Project Title: Sheridan Heights

I've completed the review and have the following questions/ comments or need the following info:

Mike Nugent
Consulting Plans Examiner
City of Portland

SHERIDAN HEIGHTS
AREA OF UNPROTECTED OPENINGS
08.14.07

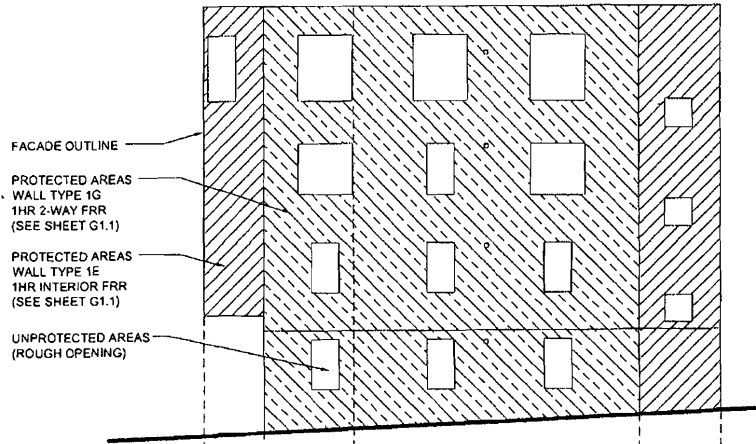
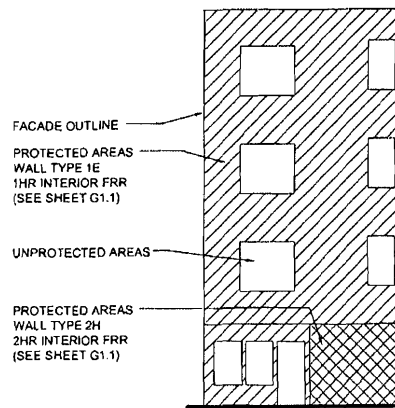
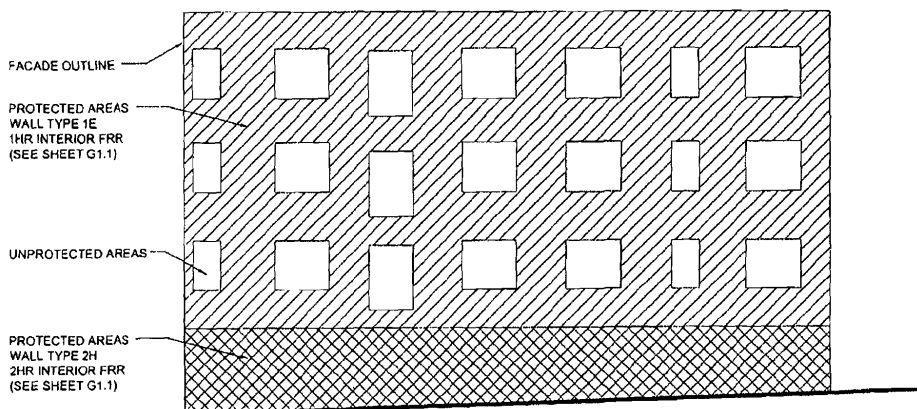
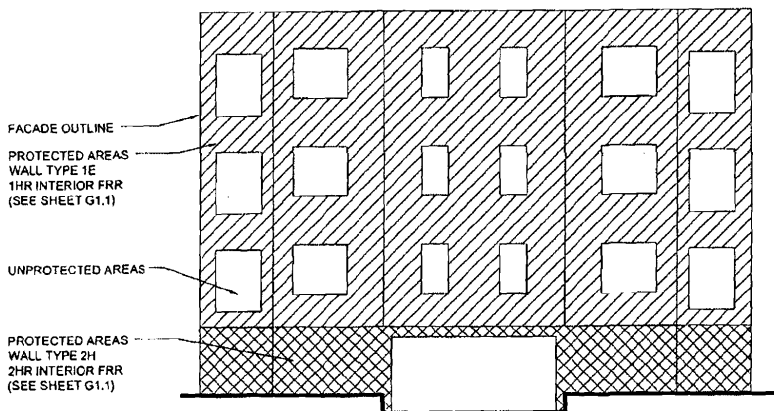
7) We received the North elevation request for waiver for the % of unprotected openings, you failed to identify the other elevations and their percentages, It looks like they all have limitations as well, please provide all elevations and their percentages THIS IS FINE BECAUSE YOU WILL BE USING A FULL NFPA 13 SYSTEM, OTHERWISE YOU CANNOT CONSIDER THE OPENINGS AS PROTECTED>

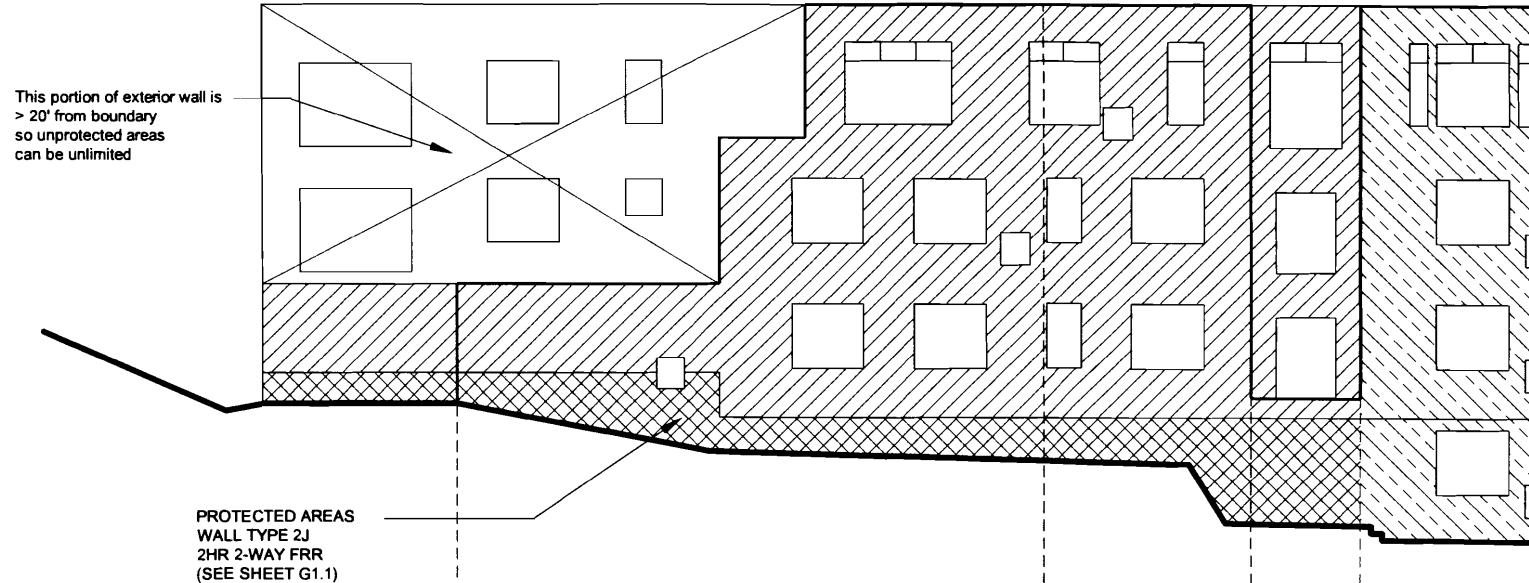
16)Need alternating tread specs and hatch details THE HATCH IS ONLY 11.25 SQ FT AND NEEDS TO BE 16 SQ.FT. THE THREADS RISERS ETC ARE FINE . DOES THE HANDRAIL MEET SECTION 1009.11, PLEASE PROVIDE CODE COMPLIANT HANDRAIL INFO?

The hatch size has been revised to a 3'-0" x 5'-6" (16.5 sqft.) Bilco Type SS-50.

The hatch dimension will increase in dimension away from the edge of roof so the 10'-4" dimension to edge of roof will be preserved.

The Handrail provided is 1-1/2" in diameter and is 34 inches above the tread nosing, both of which meet IBC 1009.11
